REMEDATION SYSTEM EVALUATION

SMS INSTRUMENTS DEER PARK, NEW YORK

Report of the Remediation System Evaluation,
Site Visit Conducted at the SMS Instruments Superfund Site
July 16, 2003

Draft Report
September 4, 2003

FIGURE 1-2. THE FORMER SMS INSTRUMENTS FACILITY, SURROUNDING AREA, AND WELL LOCATIONS.

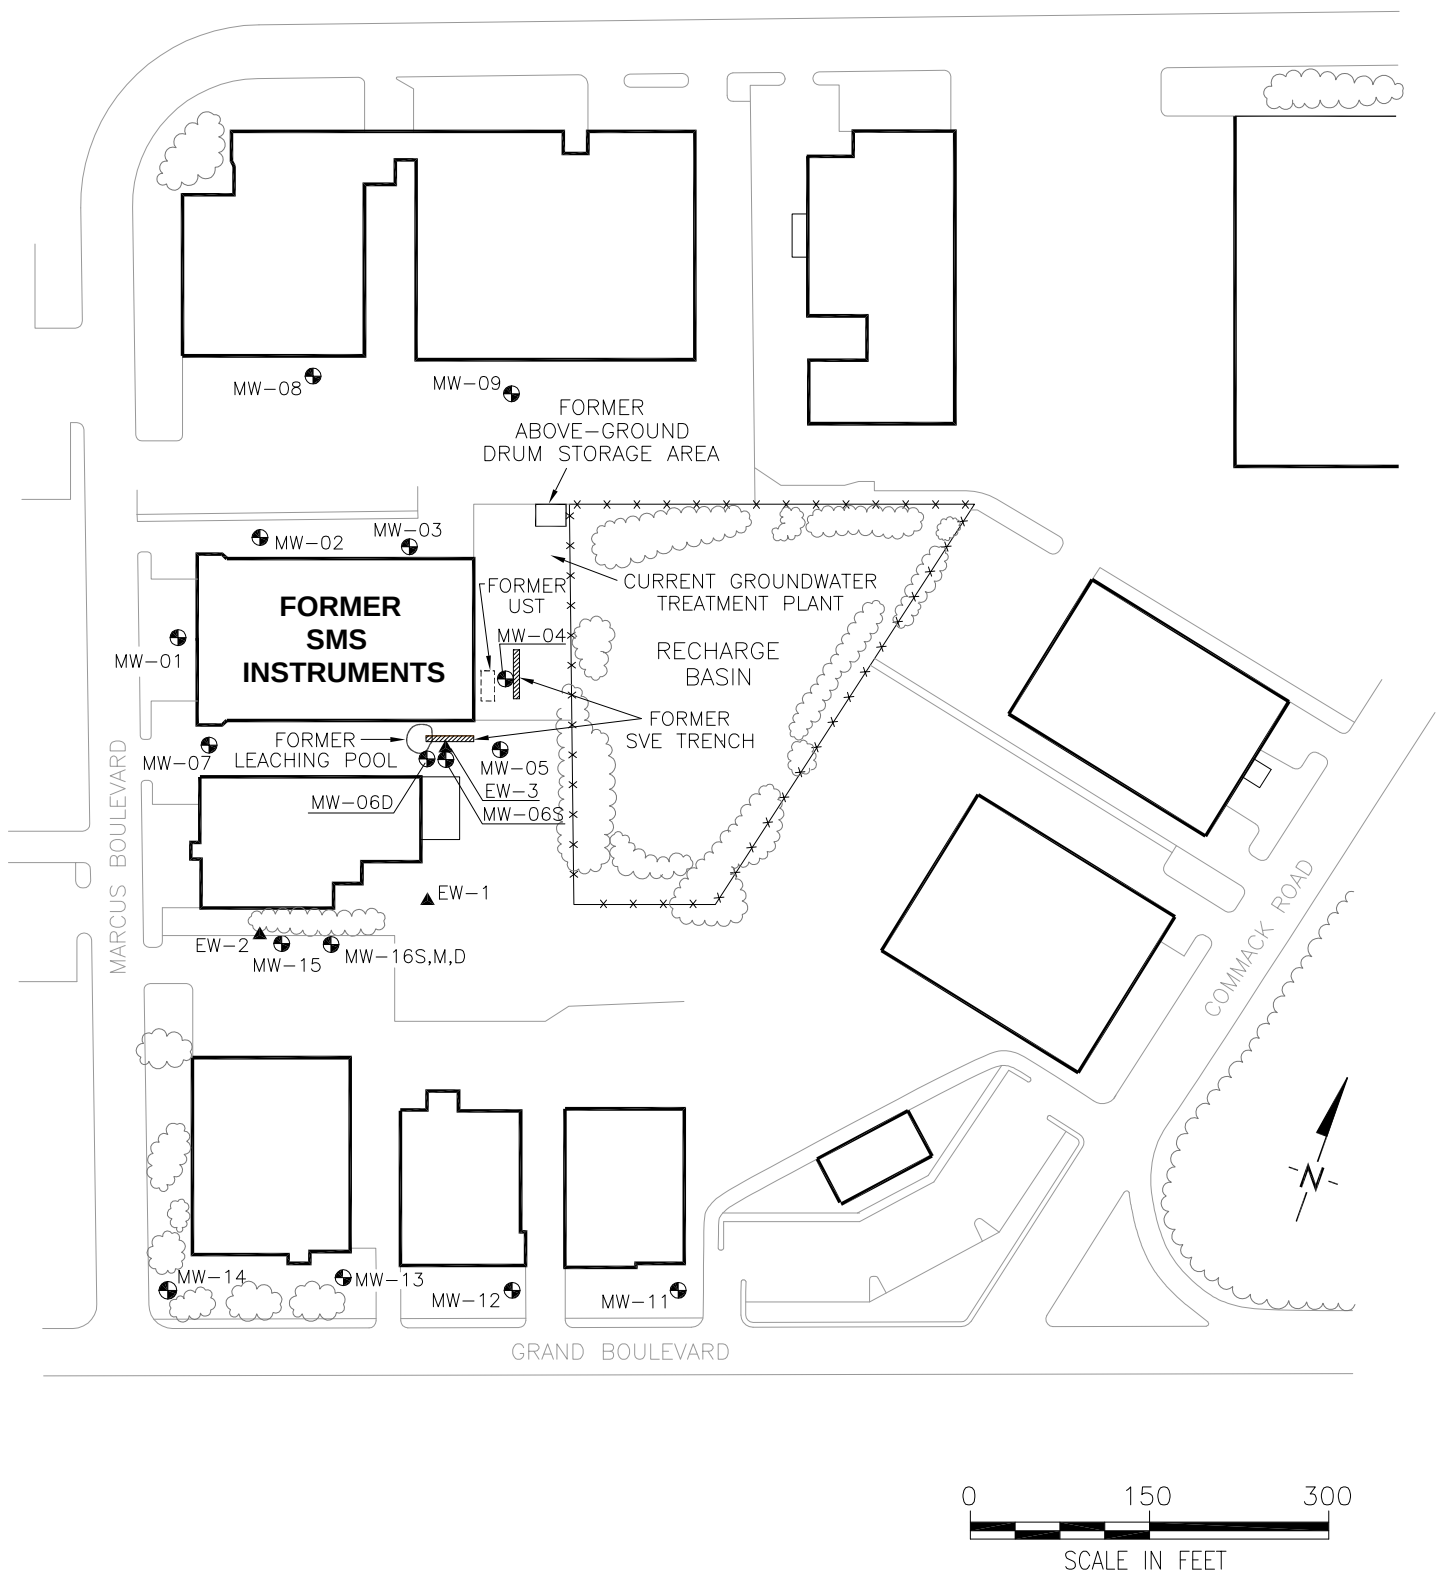
Figure 1-2 presents the locations of these wells and shows that MW-6S and EW-3 are located adjacent to each other in the area of the former leaching pond. No monitoring points are located between this area and EW-1, but given the continued contamination at EW-1, it is likely that this intermediate area has contamination above cleanup standards.

FIGURE 4-1. VOC CONCENTRATION TREND IN MW-6S

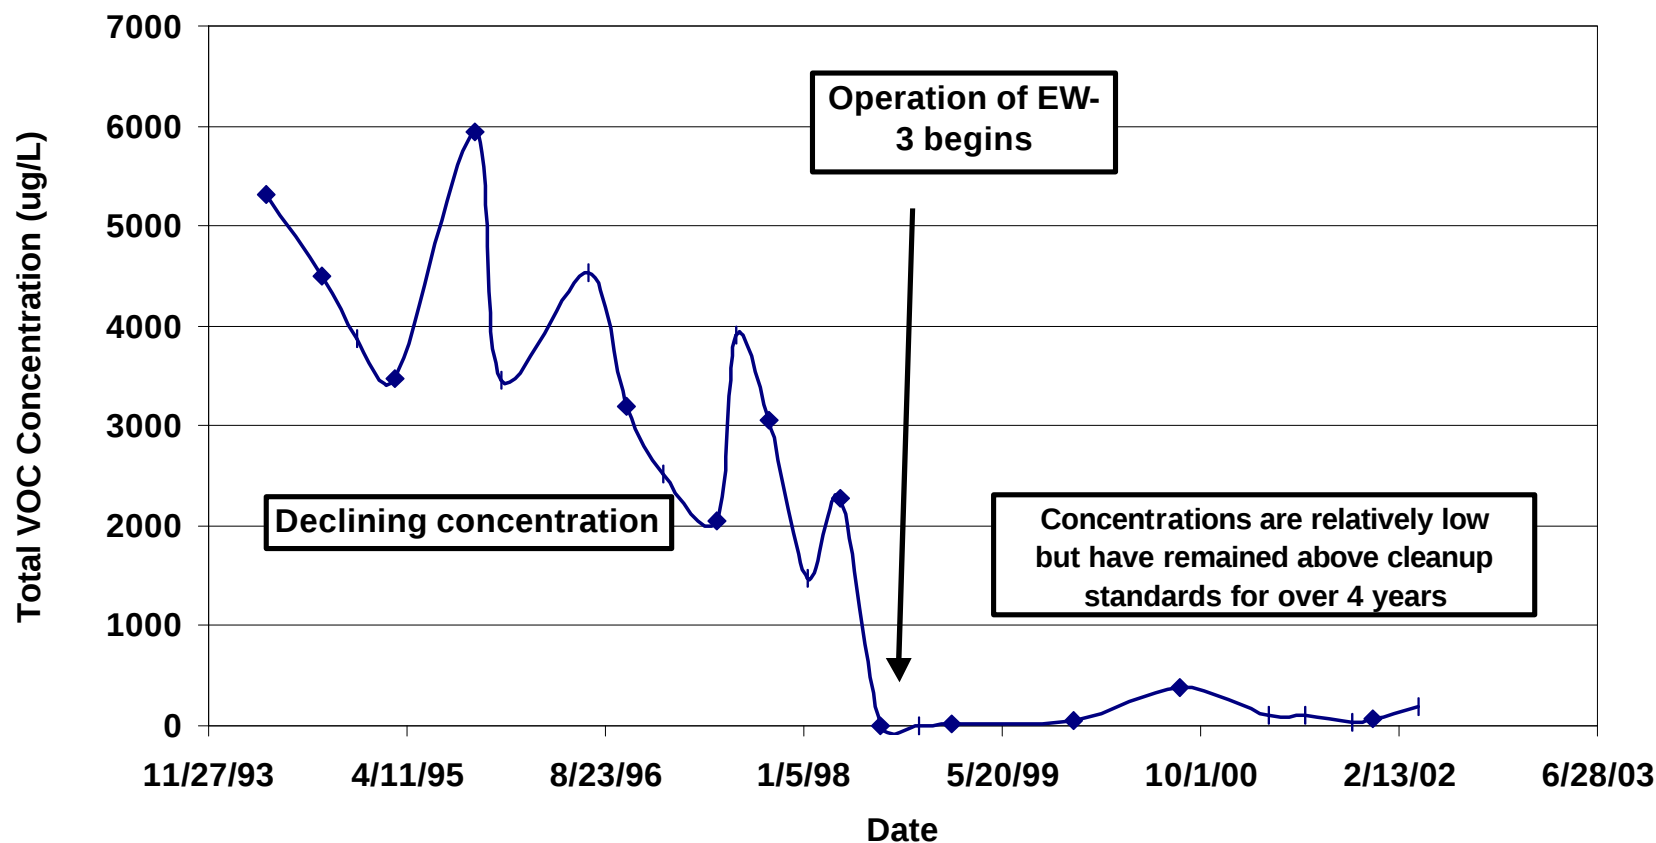
The VOC concentration in MW-6S (source area) declined between 1994 and 1998 due to the natural flushing of clean water through the site. EW-1, located at the downgradient boundary of the site, was installed to capture contamination before it moved offsite. The 1998 installation of EW-3 in the source area accelerated aquifer restoration. Concentrations are orders of magnitude lower than during the original investigations; however, they have remained consistently above cleanup standards. Data collected in sampling events since April 2002 have not been processed or reported as of July 2003.
